PLAN NO. DY.CE/CON/NJP/N-C/Y/05/2011

NEW MAL JN.-CHANGRABANDHA GAUGE CONVERSION PROJECT

PROPOSED YARD REMODELLING AT LATAGURI STATION YARD (LTG) ("B" CLASS STATION), "E" CATEGORY

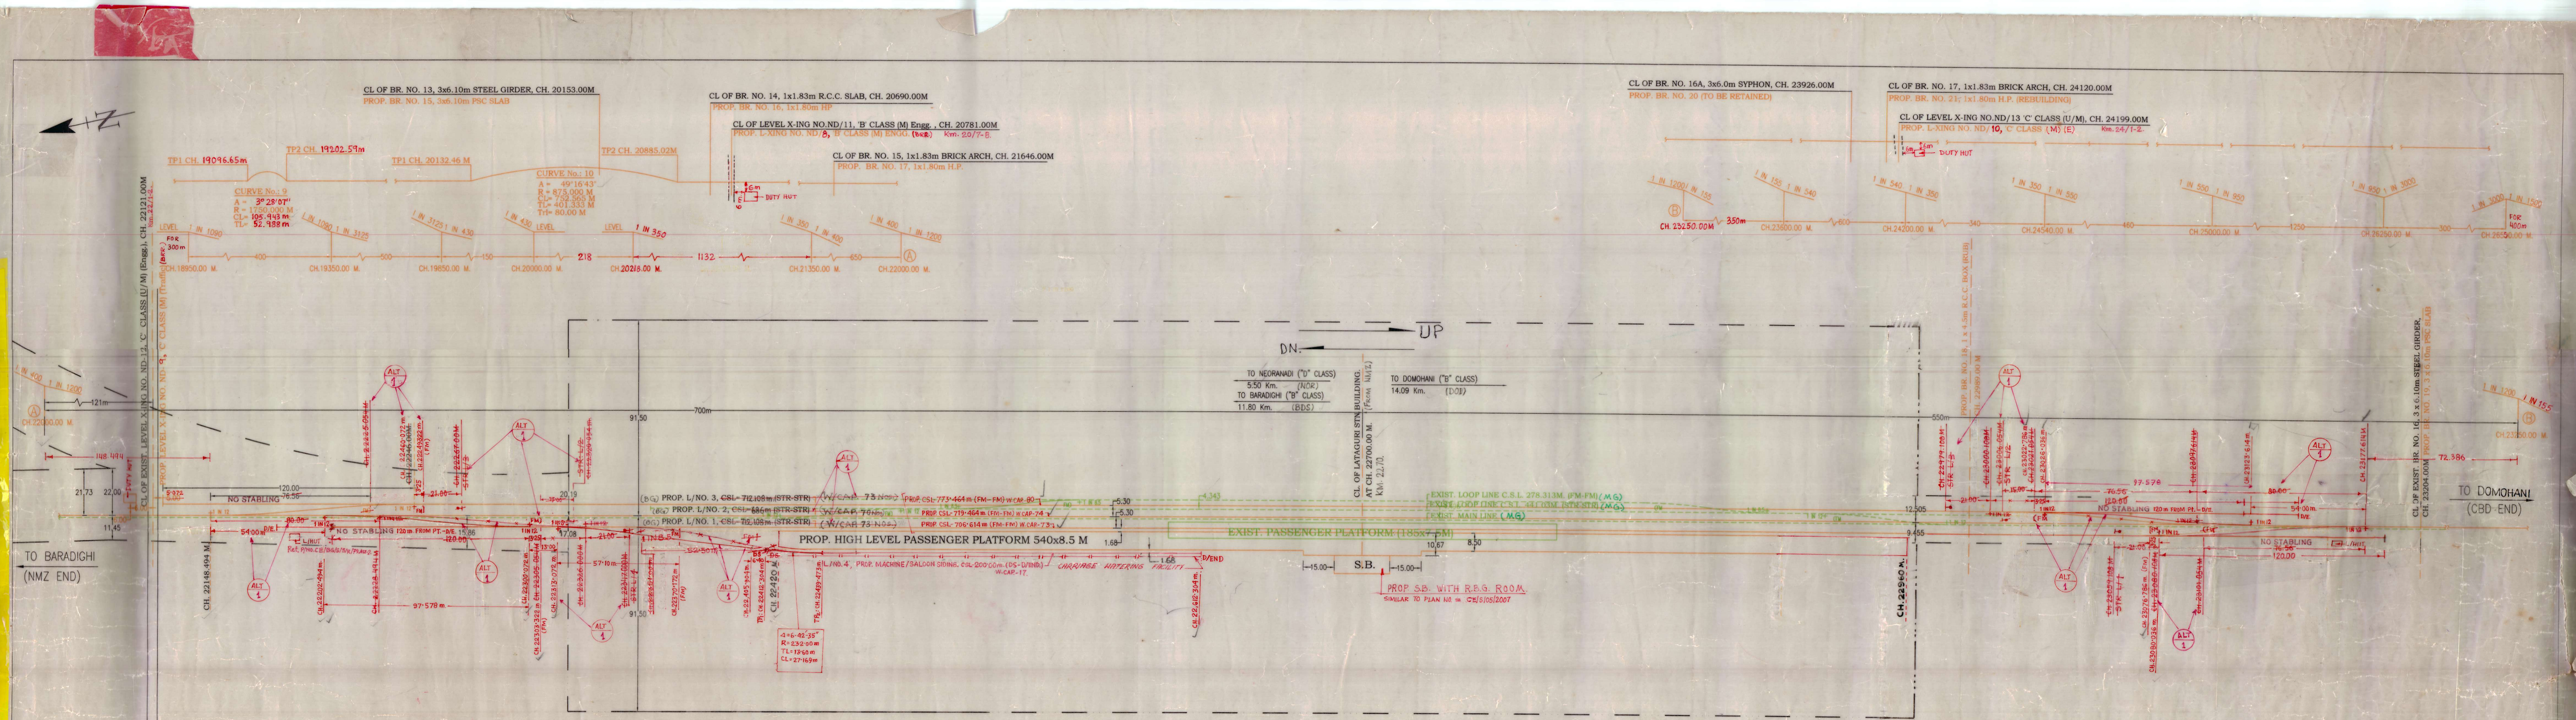
ALT NO.	DATE.	DESCRIPTION	INITIAL
1		STARTER SIGNAL POSITION HAS BEEN DELETED AND FM POSITION HAS BEEN CHANGED VIDE GM(W)/MLG'S L/NO. W/544/PLAN/W-I(W) DT. 28.01.2016. POINTS & X-ING FOR L/NO.4 FROM L/NO.1 (CH.22351.00m) AT NMZ END SHIFTED TO CH. 22313.072 m. TO PROVIDE FREE MOVEMENT ON L/NO.4 NXT. L/NO.1. X-OVER BETN. L/NO.1 & 2 AT NMZ END AND BETN. L/NO. 2 & 5 AT CBD END KEPT 54.00m. FROM 1st. FACING POINT IN PLACE OF 80m. BY SHIFTING OF 26.00m. AND CSL CORRECTED ACCORDINGLY. AS PER RECEIVED B/PRINT COPY VIDE GM/CON/MLG'S L/NO. W/344/CON/NMZ-CBD/DRG. DT. 21-08-2015 AND OFFICE CASE FILE NO. W/BI/APDJ/CONSTN/W-I (WORKS) OF SN/55.	XEN/W-I/MLG. CTPM/MLG. CSTE/PL&G. CE/PL&G. CPDE/MLG.
